Access Compliance Report Public Rights-of-Way (Curb Ramps)

Intersection ID: 12625 Main Street: E_10TH_ST Cross Street: E_12TH_ST Location: N

ADA ID: A7E94A524BC3 Ramp Type: BlendTrans1 Initial Pass/Fail: Fail **Overall Compliance: No Severity Score:** 8.75

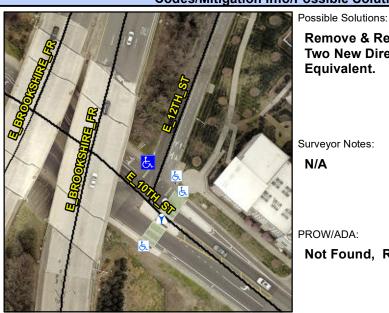
Not Found, R304.5.1

Field Measurements/Component Compliance					
Compliance Description E		Data	Compliance Description		Data
N/A	Ramp Length (in)	119.0	Yes	BlendTrans Slope (%)	3.1
No	Ramp Width (in)	46.0	Yes	BlendTrans XSlope (%)	1.5
N/A	Flare Type LT	N/A	N/A	Flare Type RT	N/A
N/A	Flare Slope LT (%)	N/A	N/A	Flare Slope RT (%)	N/A
N/A	Flare Traversable LT?	N/A	N/A	Flare Traversable RT?	N/A
N/A	Landing Length (in)	N/A	N/A	DWS Provided?	N/A
N/A	Landing Width (in)	N/A	N/A	DWS Contrast?	N/A
N/A	Landing Slope (%)	N/A	N/A	DWS Length (in)	N/A
N/A	Landing X Slope (%)	N/A	N/A	DWS Full Width?	N/A
N/A	Landing Curb? (Y/N)	N/A	N/A	DWS Offset (in)	N/A
N/A	Shared Landing?	N/A			
N/A	Gutter Ponding?	Yes	N/A	Gutter Slope (%)	N/A
N/A	Gutter Lip Ht (in)	1.0	N/A	Gutter X Slope (%)	N/A
N/A	Painted X Walk1?	No	N/A	Painted X Walk2?	N/A
	X Walk 1 Direction	To SE		X Walk 2 Direction	N/A
	X Walk 1 Width (in)	N/A		X Walk 2 Width (in)	N/A
	X Walk 1 Slope (%)	0.8		X Walk 2 Slope (%)	N/A

X Walk 1 X Slope (%)	2.1		X Walk 2 X Slope (%)	N/A
N/A	Ramp inside XWalk1?	N/A	N/A	Ramp inside XWalk2?	N/A
	Road Slope (%)	2.1		Clear Space?	N/A
	Road X Slope (%)	0.8	N/A	Clear Space to XWalk (in)	N/A
N/A	Any Obstructions?	N/A	N/A	Storm Grate/Utility Hazard?	N/A
	Obstruction Type			Storm Grate/Utility Type	
		N/A			N/A
			Yes	Surface Condition? (G/P)	Good
			No	Curb Slope (%)	8.5

E 12TH ST Street 1 Name Stop Condition-Street 1 None Street 2 Name N/A Stop Condition-Street 2 N/A Remove & Replace Curb Ramp With Two New Directional Ramps or Equivalent.
